ADDENDUM NO. 4

BRACKISH WATER DESALINATION PROJECT P.W. 694

ISSUED November 10, 2020

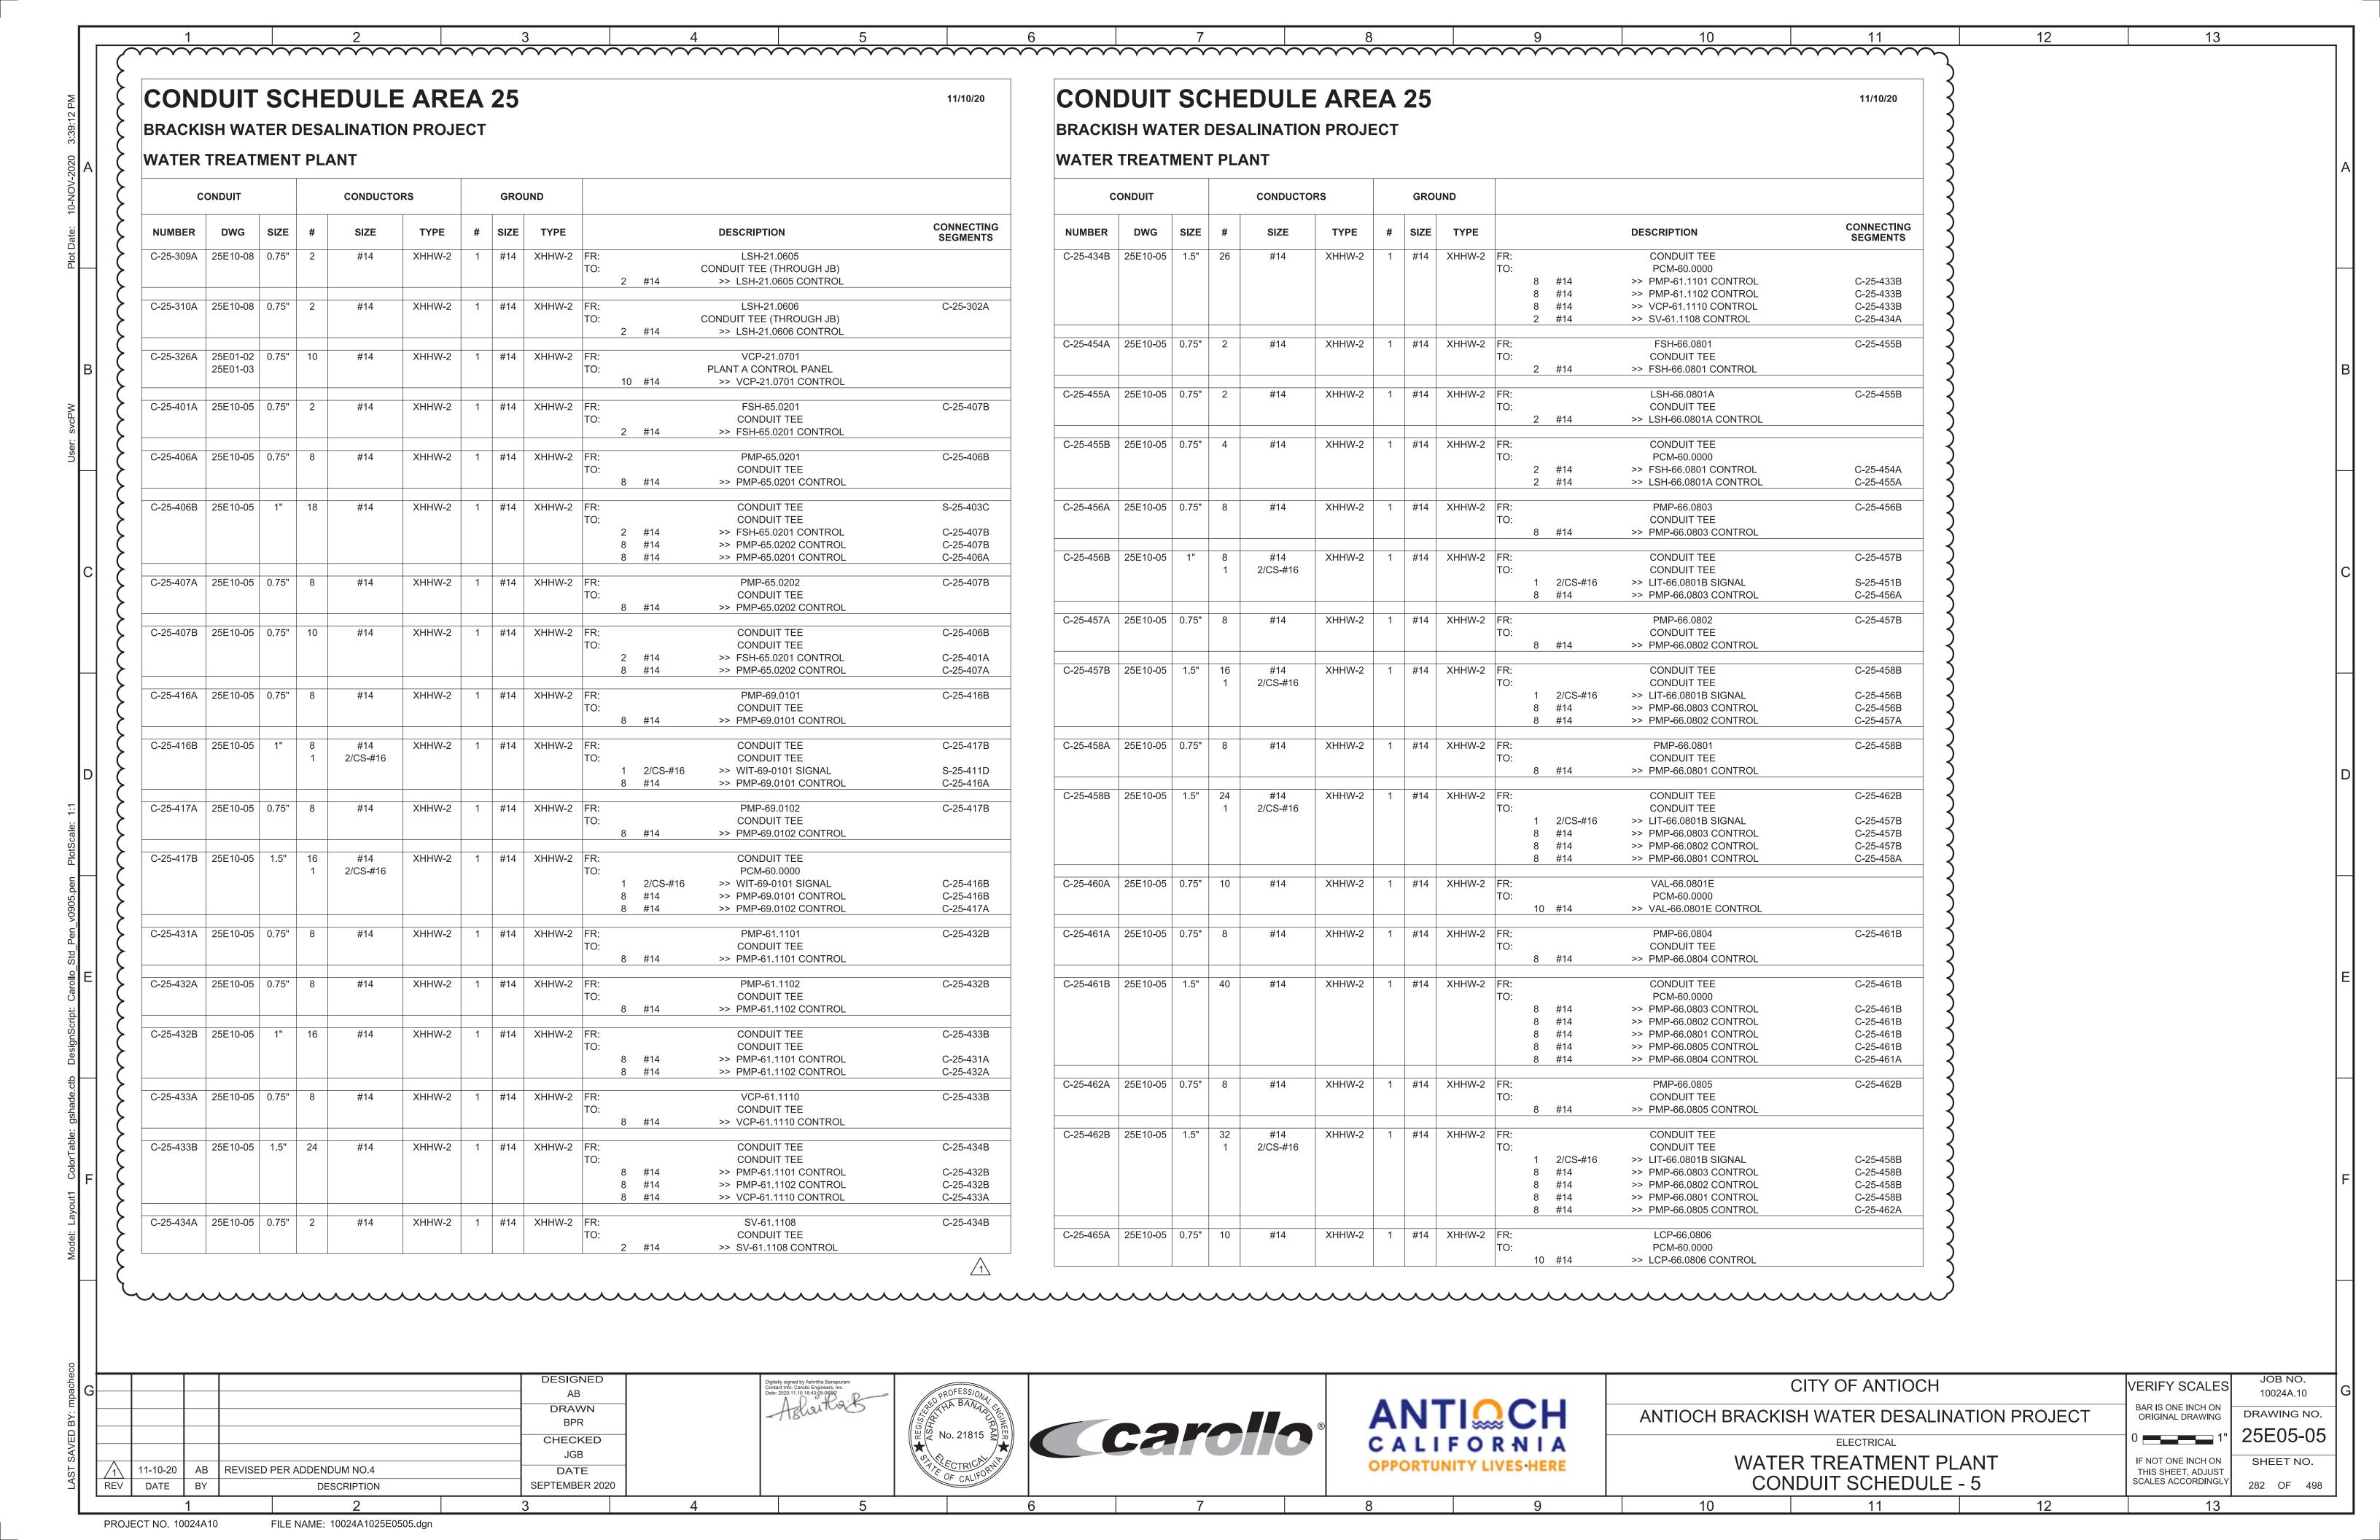
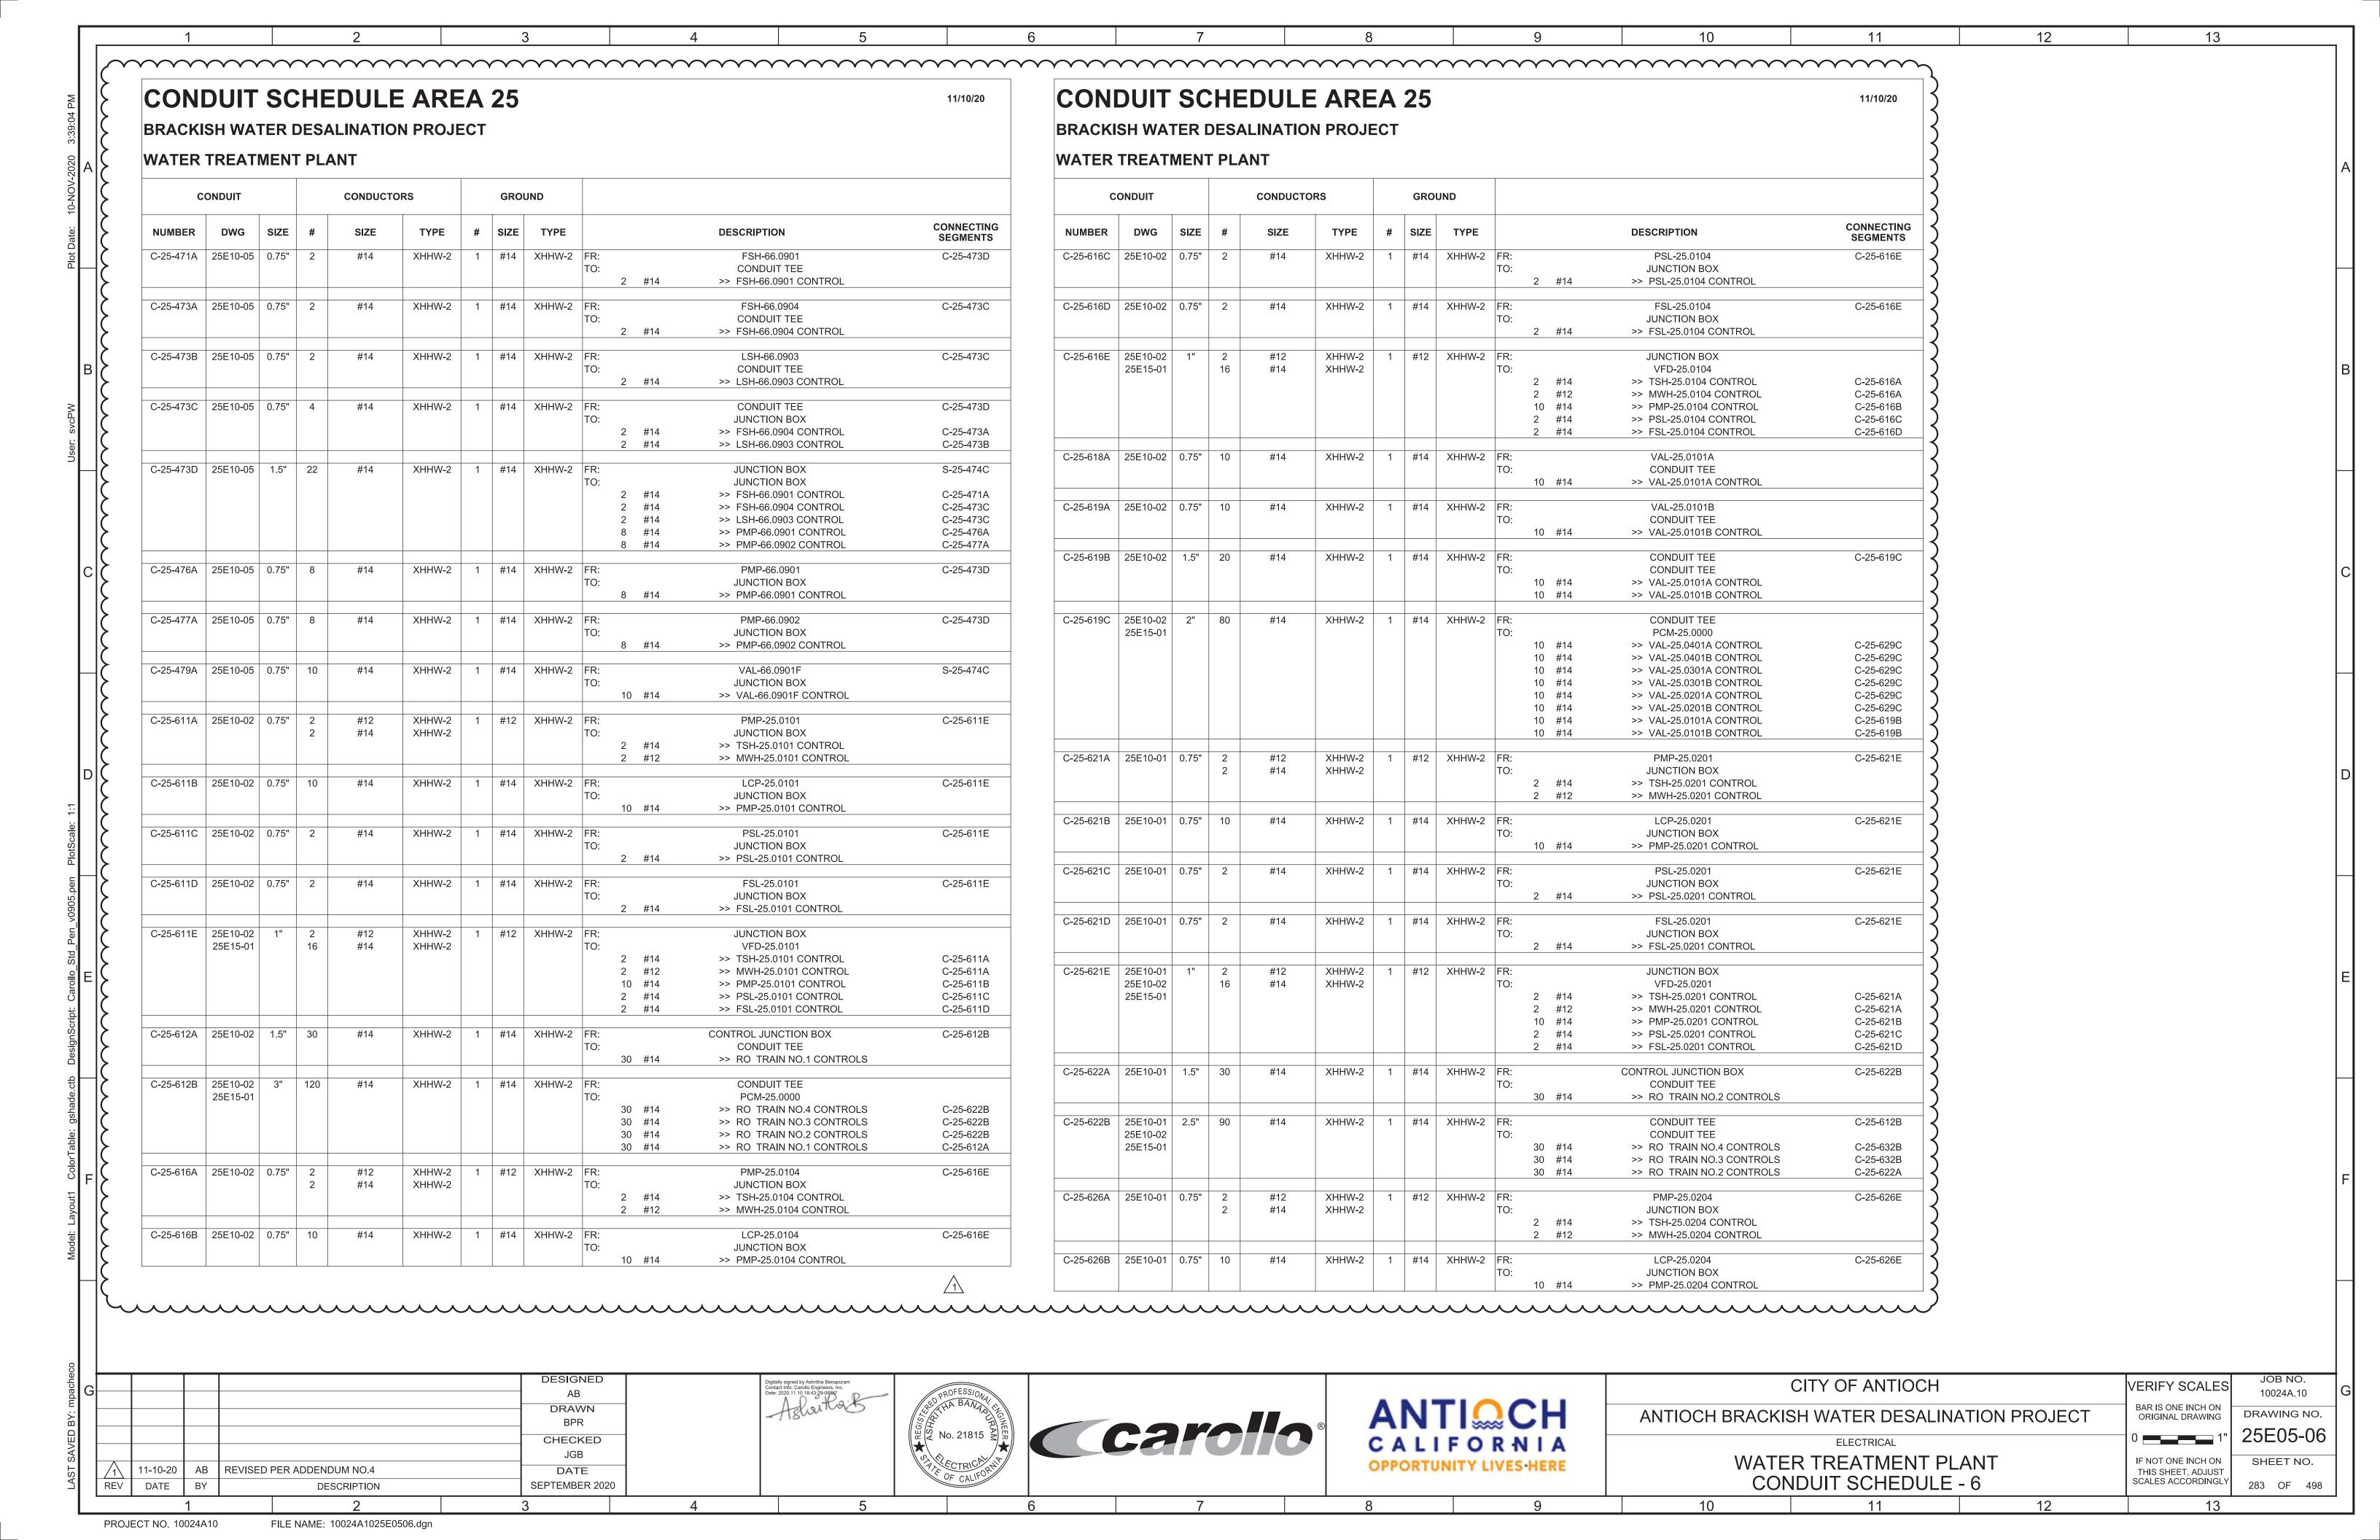
В	RACK	ISH W		ESAL	DULE INATION IT						11/10/20	CONE BRACKIS WATER 1	SH W	ATER DE	SALINAT			25				11/10/20				
	C	CONDUIT		ı	CONDUCTOR	.s	GRO	DUND				cc	ONDUIT		CONDU	CTORS		GROUND	D				}			
ı	NUMBER	DWG	SIZE	#	SIZE	TYPE	# SIZE	TYPE		DESCRIPTION	CONNECTING SEGMENTS	NUMBER	DWG	SIZE	# SIZE	TYPE	E # S	SIZE	TYPE		DESCRIPTION	CONNECTING SEGMENTS	}			
C	C-25-184C	25E01-0		80 19	#14 2/CS-#16	XHHW-2	1 #14	XHHW-2	FR: TO: 10 #14	JUNCTION BOX PCM-25.0001 >> VAL-24.0602B CONTROL	S-25-167B	C-25-214A	25E01-0	0.75"	10 #14	XHHW	7-2 1	#14 X	(HHW-2 FR TO	: :: 10 #14	G-25.0004E JUNCTION BOX >> G-25.0004E CONTROL	C-25-214B	}			
									2 2/CS-#16 1 2/CS-#16 10 #14	>> VAL-24.0602B SIGNAL >> FIT-24.0604B SIGNAL >> VAL-24.0604B CONTROL	S-25-167B S-25-167B S-25-167B	C-25-214B	25E01-0		20 #14 1 2/CS-# ²		Y-2 1	#14 X	(HHW-2 FR	:	JUNCTION BOX PCM-25.0001		}			
									2 2/CS-#16 10 #14	>> VAL-24.0604B SIGNAL >> VAL-24.0604A CONTROL	S-25-167B S-25-167B		25E10-0		2/03-#	0				10 #14 10 #14	>> G-25.0004A CONTROL >> G-25.0004E CONTROL	C-25-210A C-25-214A	}
